UNITED STATES PATENT AND TRADEMARK OFFICE

APPLICATION NO.	FILING DATE	FIRST NAMED INVENTOR	ATTORNEY DOCKET NO.	CONFIRMATION NO.
10/749,685	12/31/2003	Steven T. Adamy	55216	2168

Office Action Summary

DETAILED ACTION

Figure 3

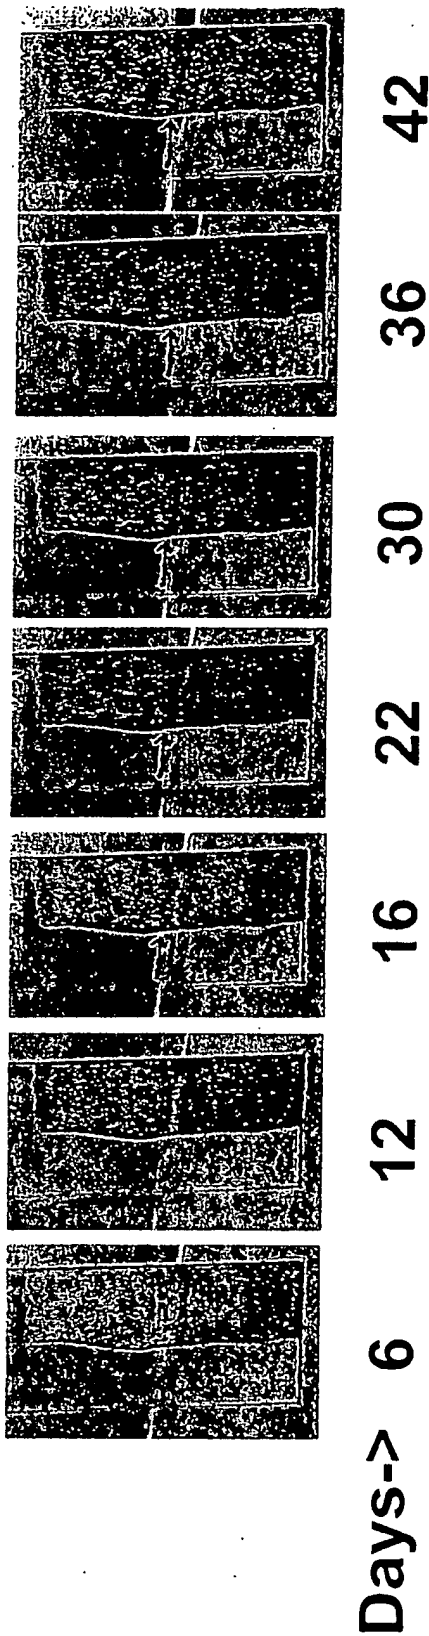
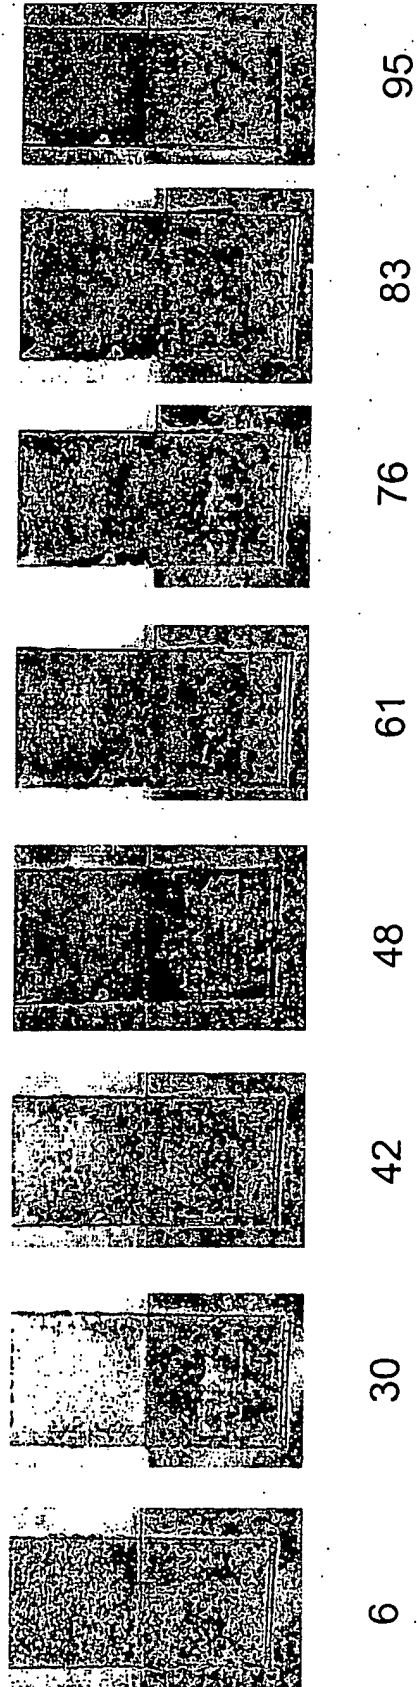
Not Approved
TmR 2/6/04
